**1958 Agreement – Consideration of draft amendments  
to existing Regulations submitted by GRSP**

## **Proposal for the 04 series of amendments to Regulation No. 11 (Door latches and hinges)**

### **Submitted by the Working Party on Passive Safety \***

**Model A**

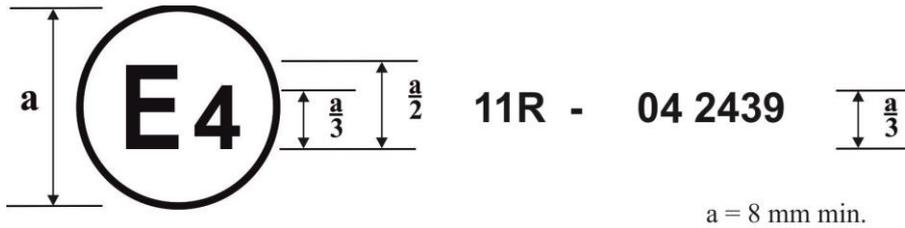
Annex 2, amend to read:

The above approval ... Regulation No. 11, under approval number 042439...

**Model B**

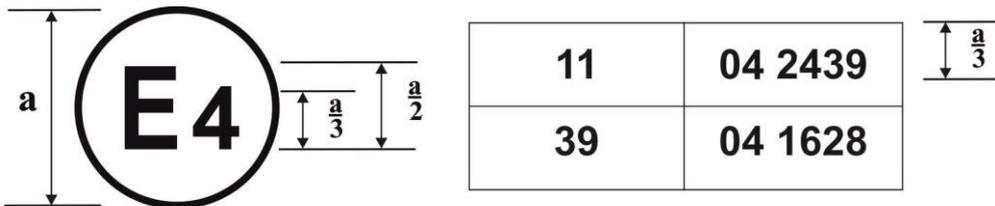
The above approval mark ... Regulation No. 11 as amended by the 04 series of amendments ..."
